[11] **Patent Number: Des. 417,632**

[54] **MASONRY FIXTURES**

UNITED STATES PATENT AND TRADEMARK OFFICE
CERTIFICATE OF CORRECTION

PATENT : Des. 417,632

FIG. 5

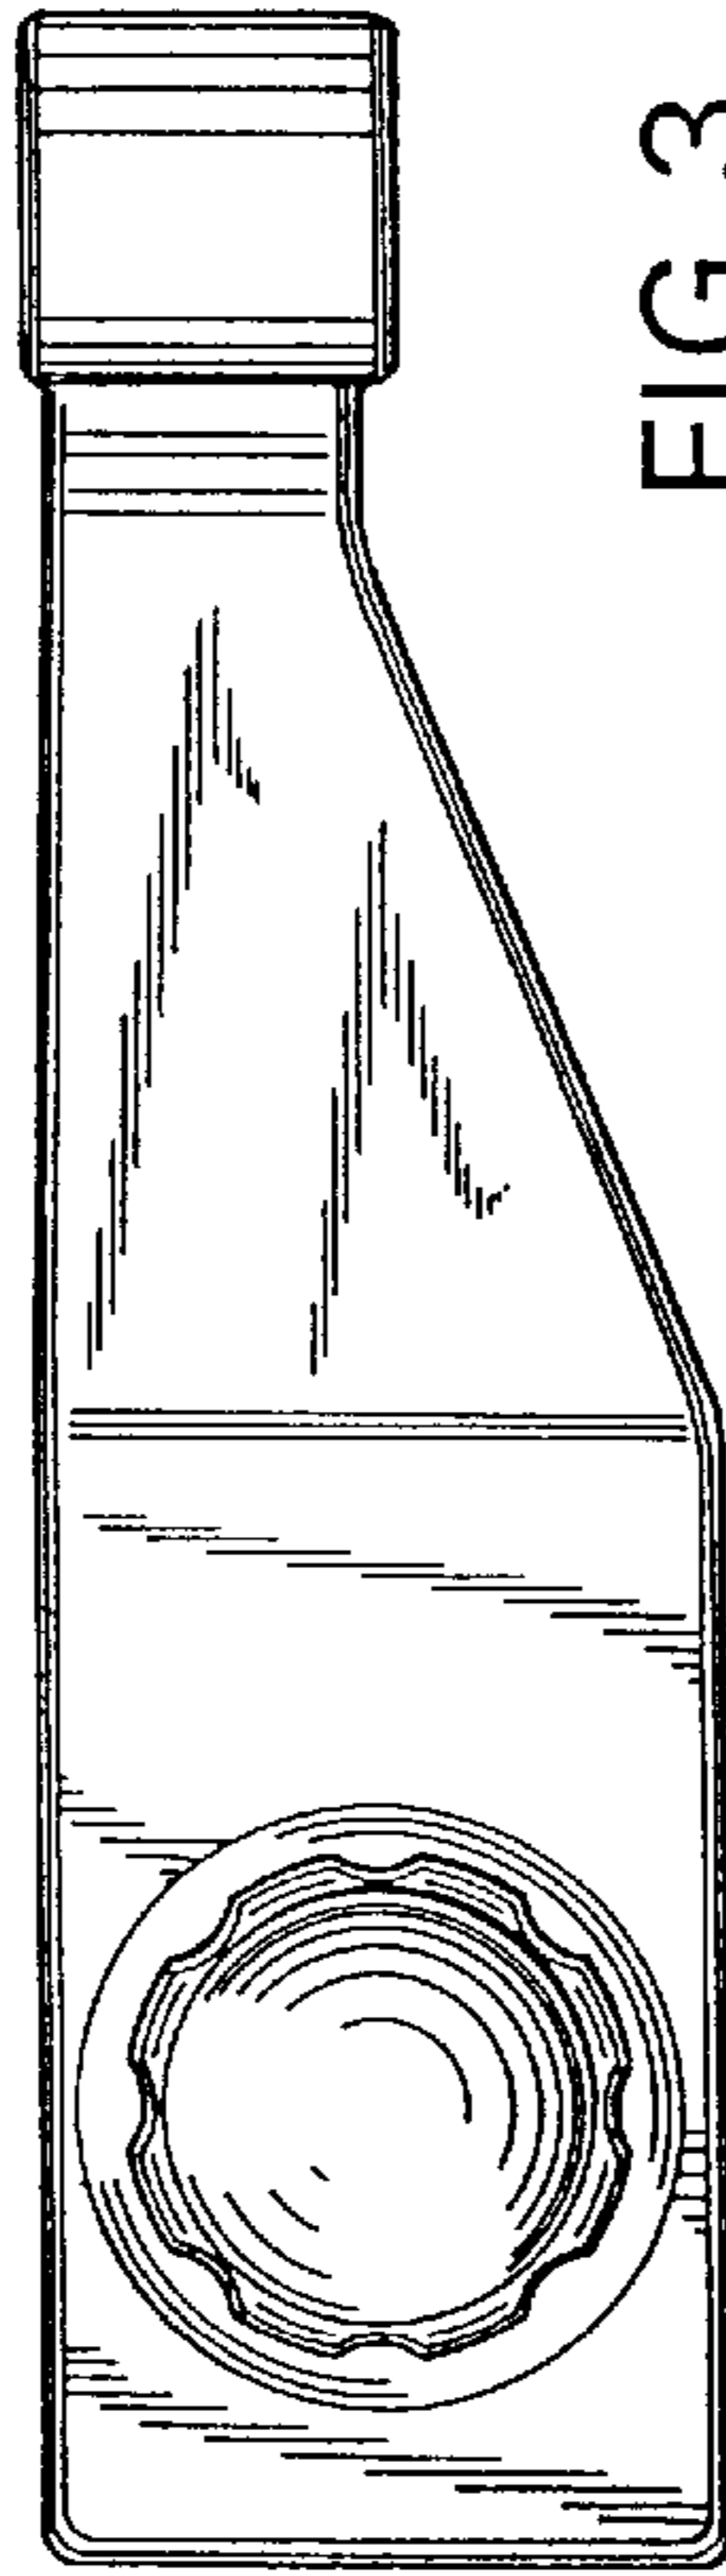
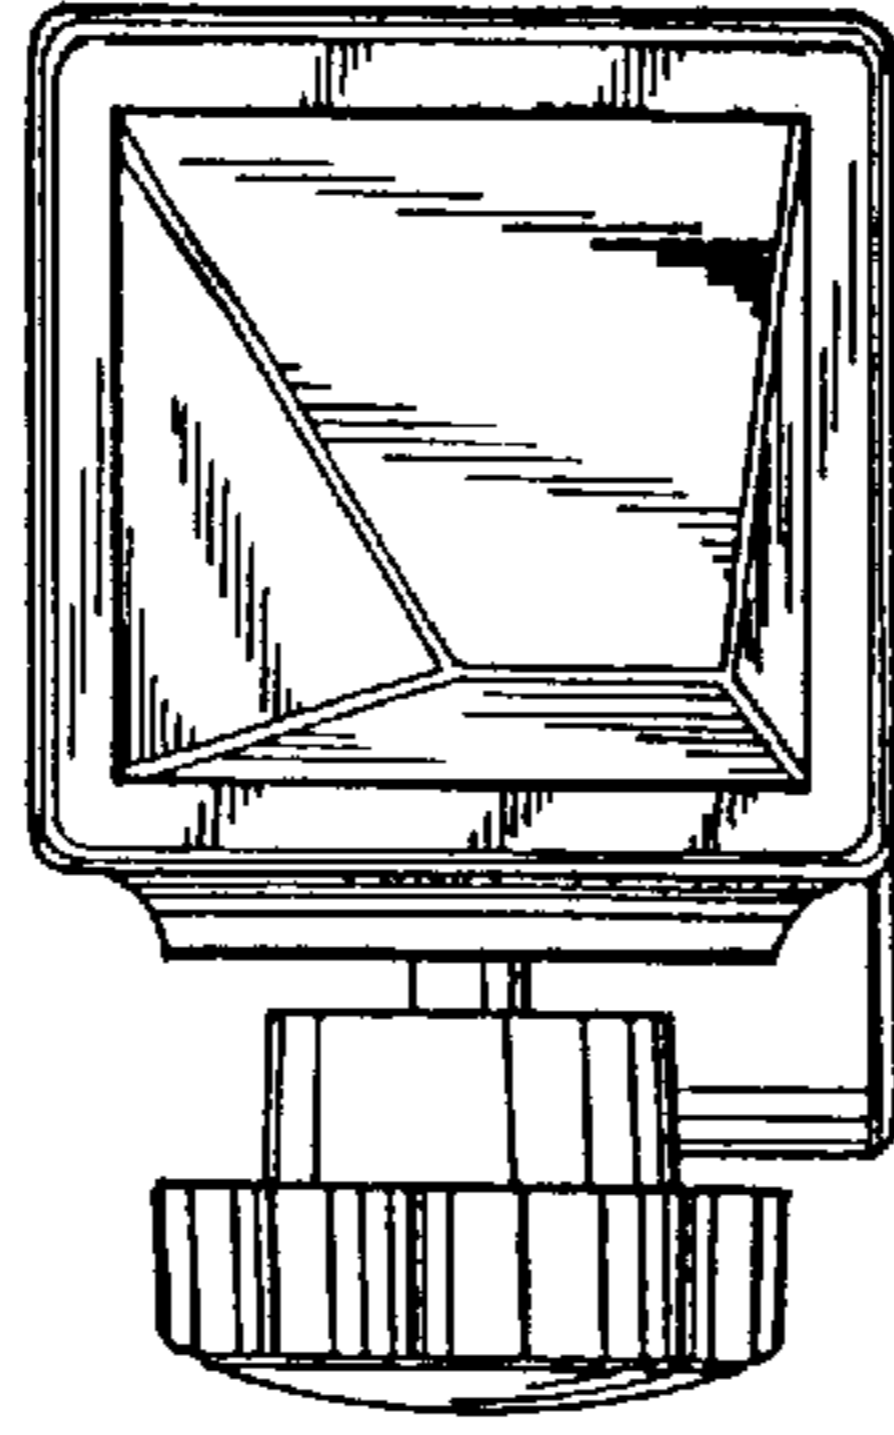
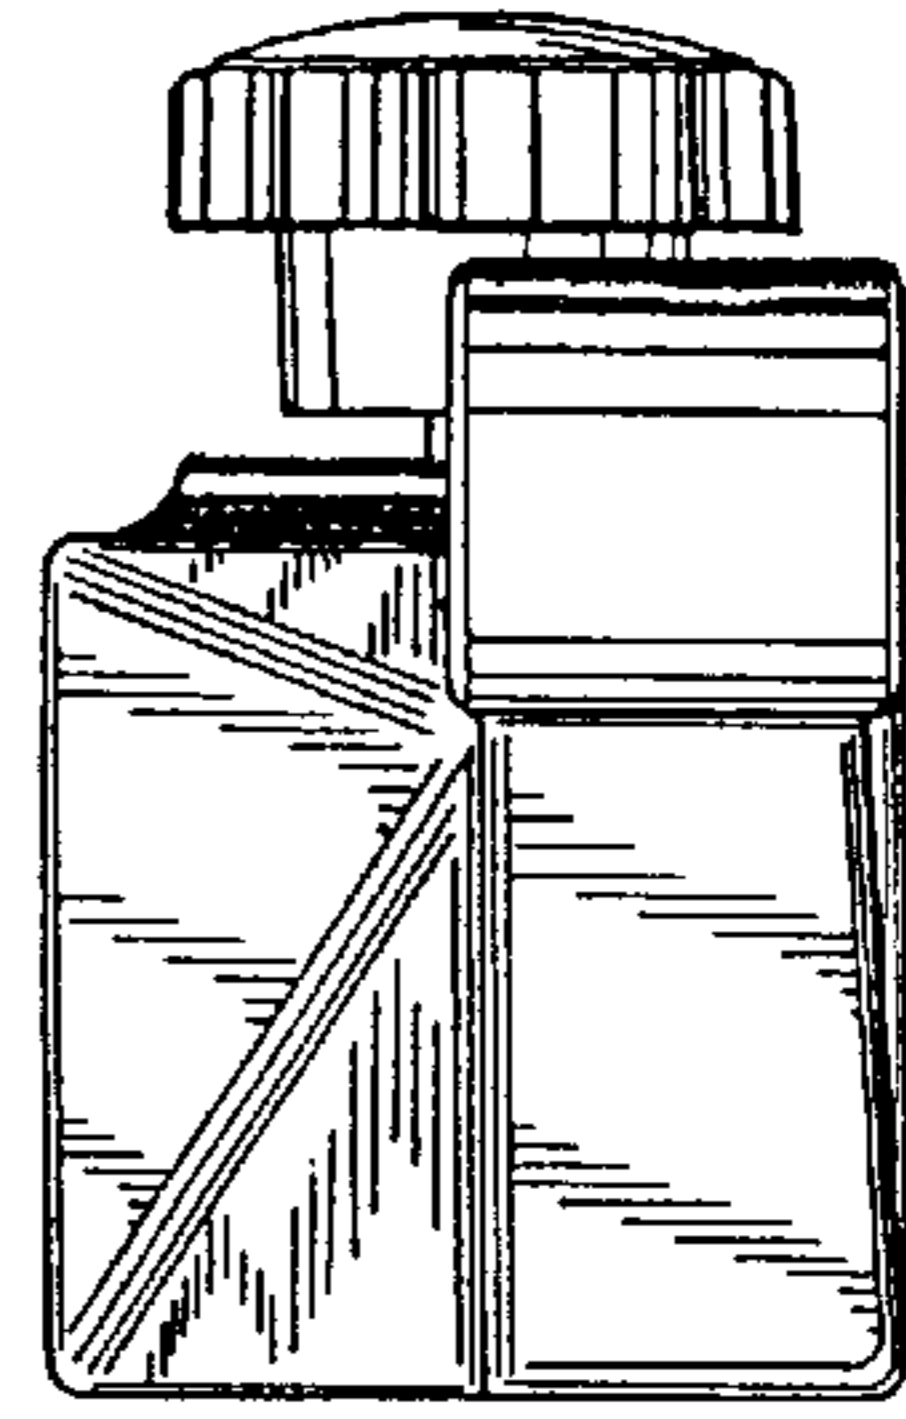
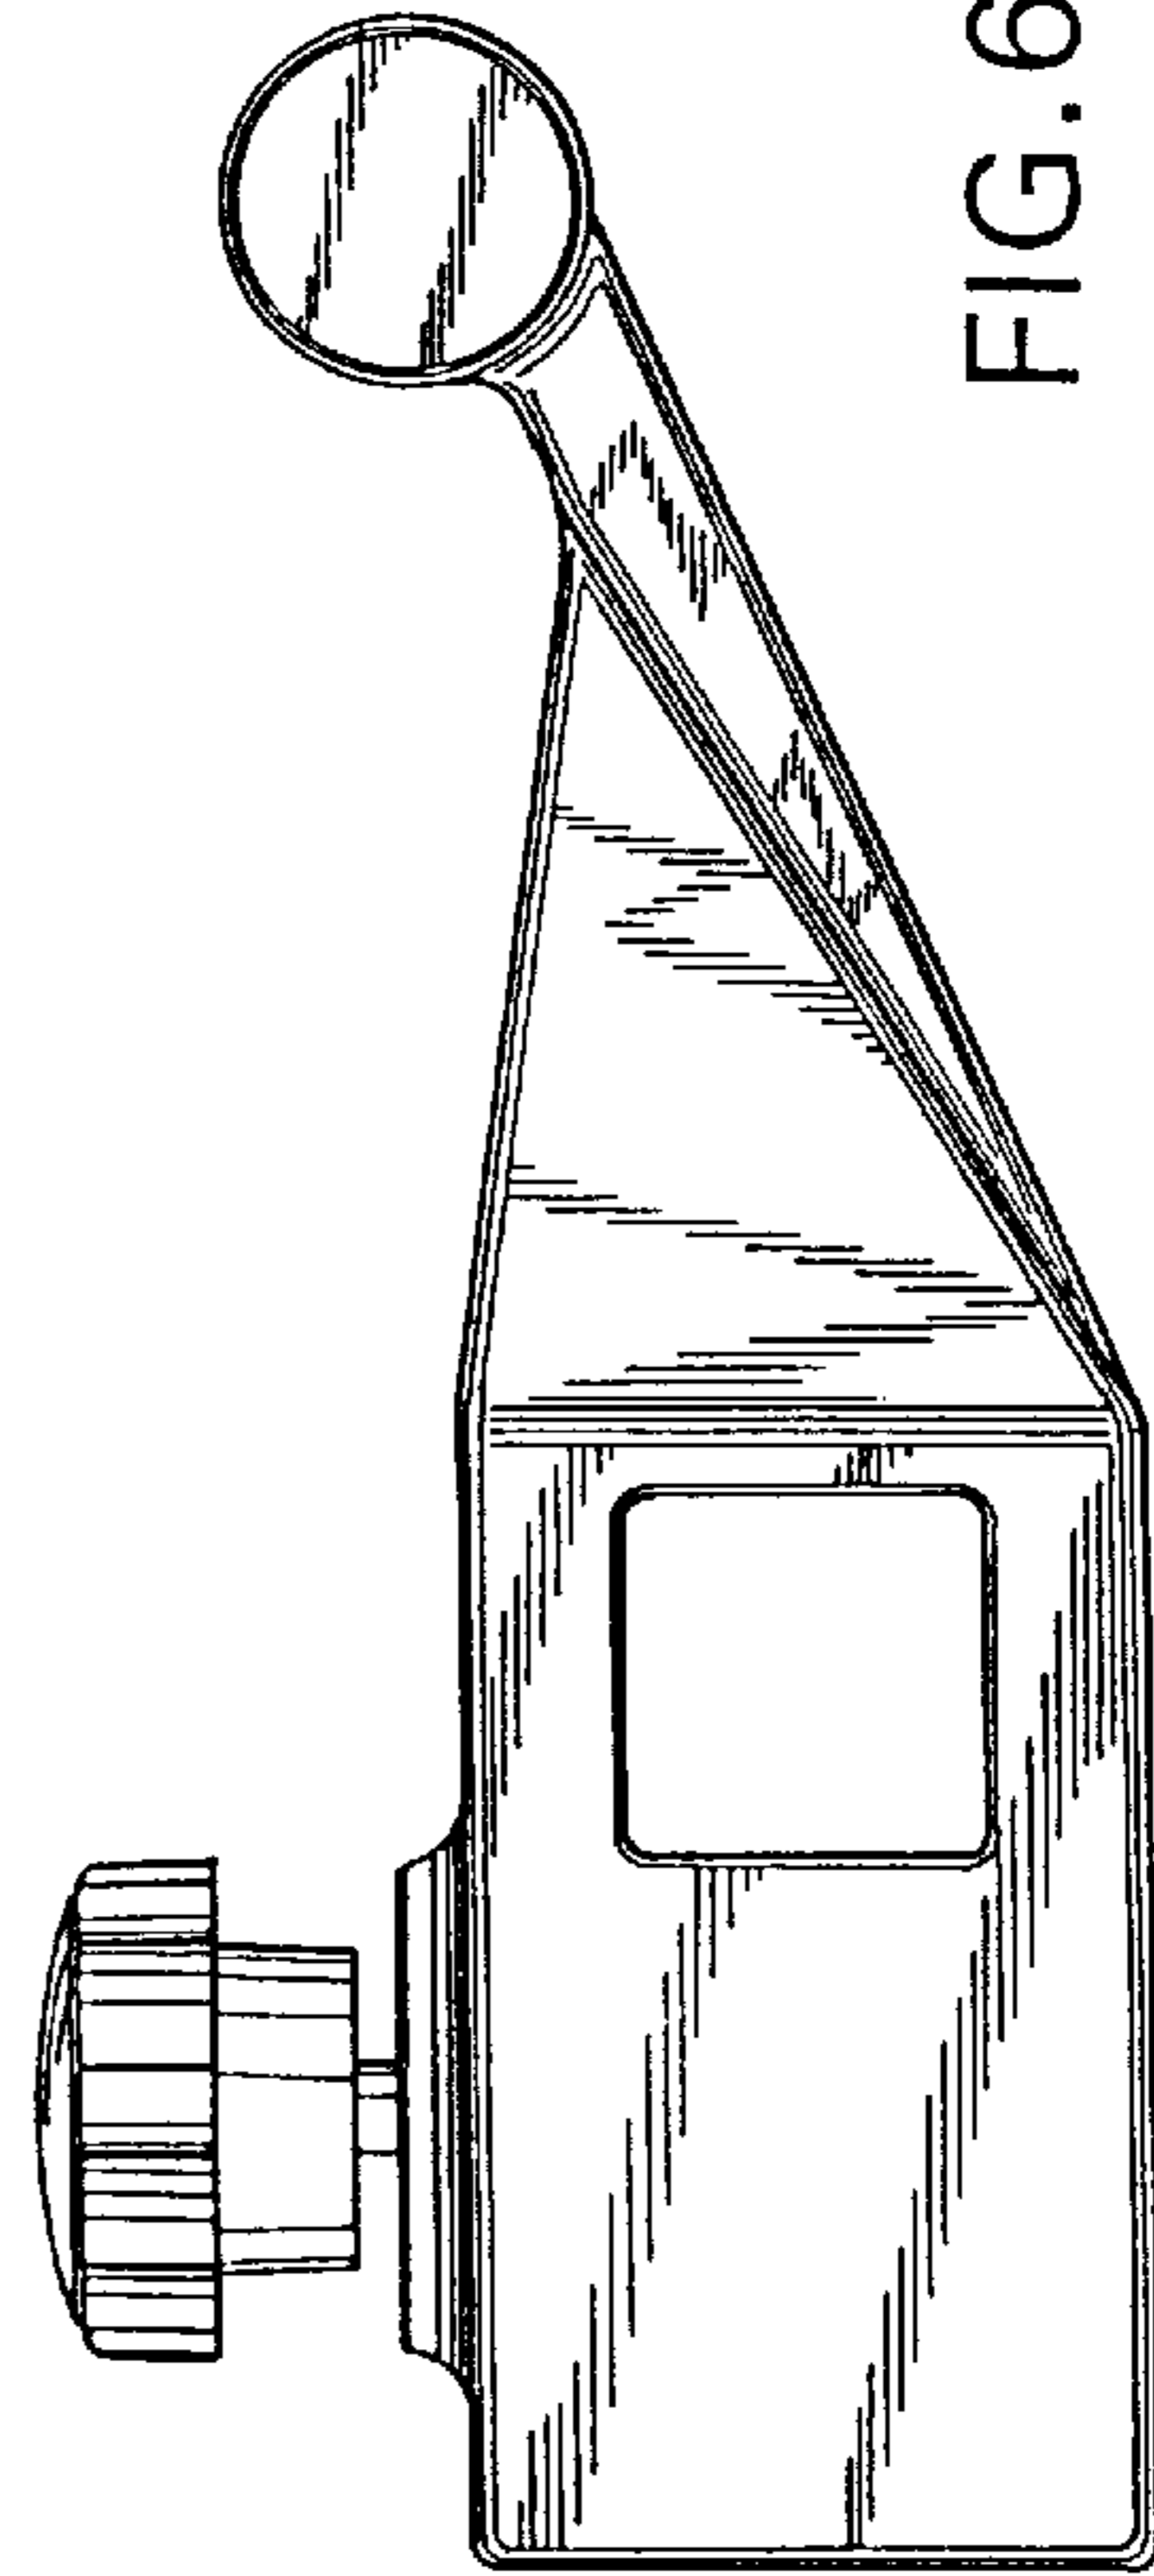
In the drawings, sheets 1 and 2, consisting of Figs. 1-7 should be deleted to be replaced with sheets 1 and 2, consisting of Figs. 1-7, as shown on the attached pages.
